APPLICATION NO.	FILING DATE	FIRST NAMED INVENTOR	ATTORNEY DOCKET NO.	CONFIRMATION NO.
10/790,583	03/01/2004	David Wiekhorst	65823-0540	9881
23552	7590	10/05/2005		
MERCHANT & GOULD PC P.O. BOX 2903 MINNEAPOLIS, MN 55402-0903			EXAMINER LEE, JINHEE J	
			ART UNIT 2831	PAPER NUMBER

Office Action Summary	Application No. 10/790,583	Applicant(s) WIEKHORST ET AL.	
	Examiner Jinhee J. Lee	Art Unit 2831

DETAILED ACTION

FIG. 6

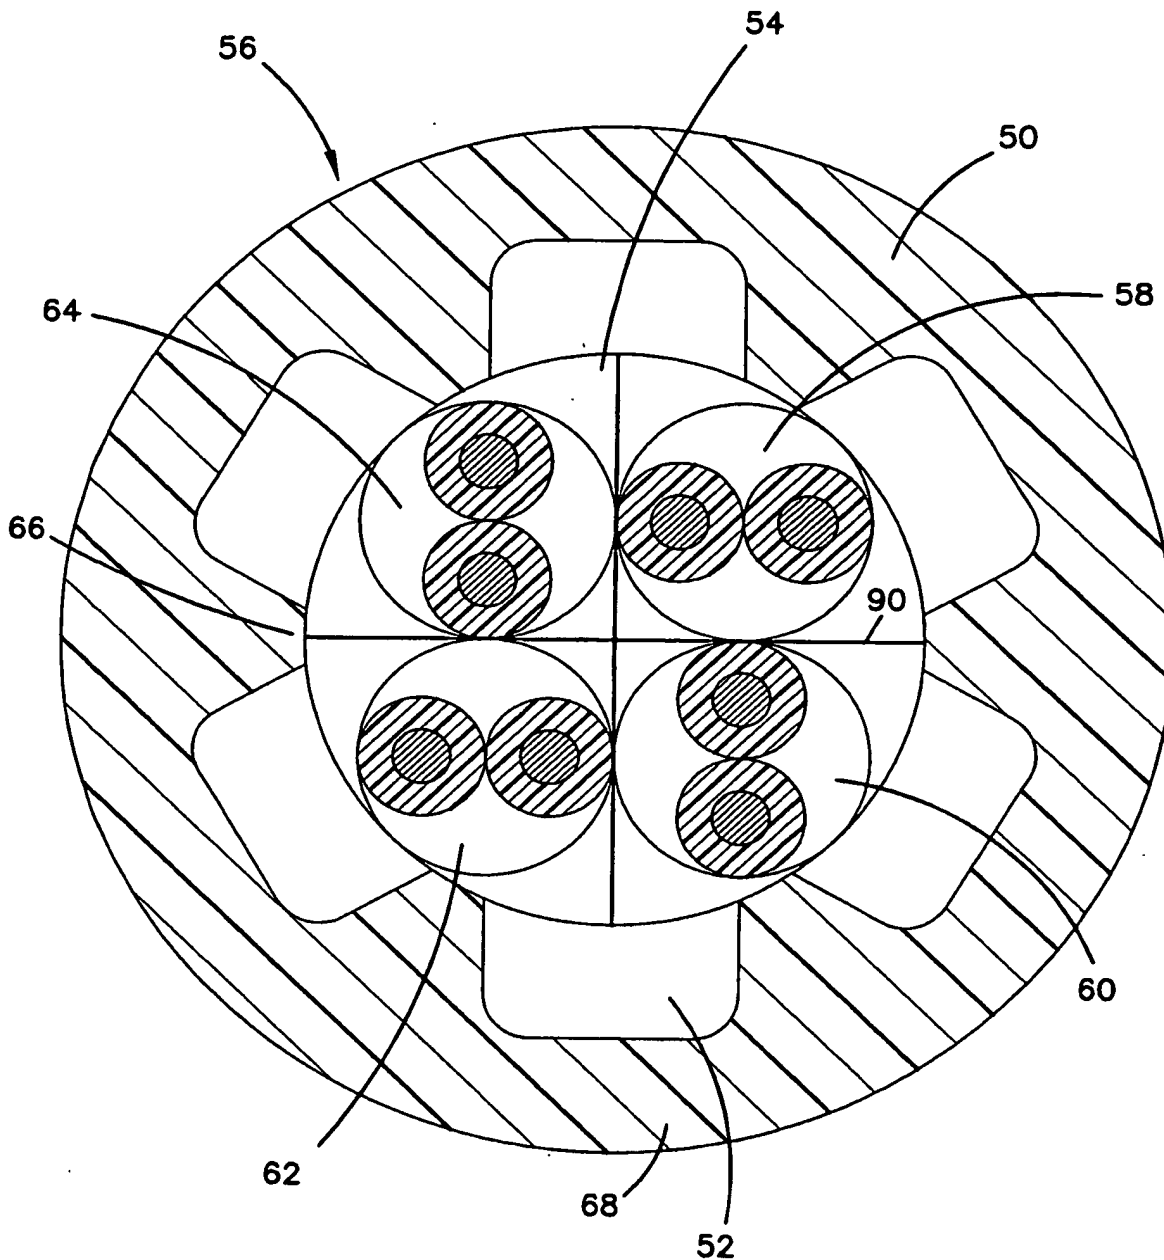
Separator 90 on replacement figure 6 is new matter and was not previously disclosed in such a way as to reasonably convey to one skilled in the relevant art that the inventor(s), at the time the application was filed, had possession of the claimed invention. Applicant is required to cancel the new matter.

Not Approved 9/22/05

FIG. 7

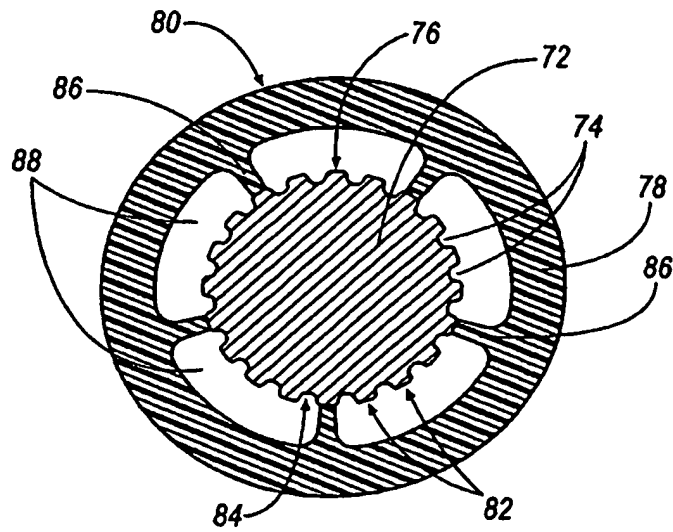
Not Approved *[Signature]* 9/24/05
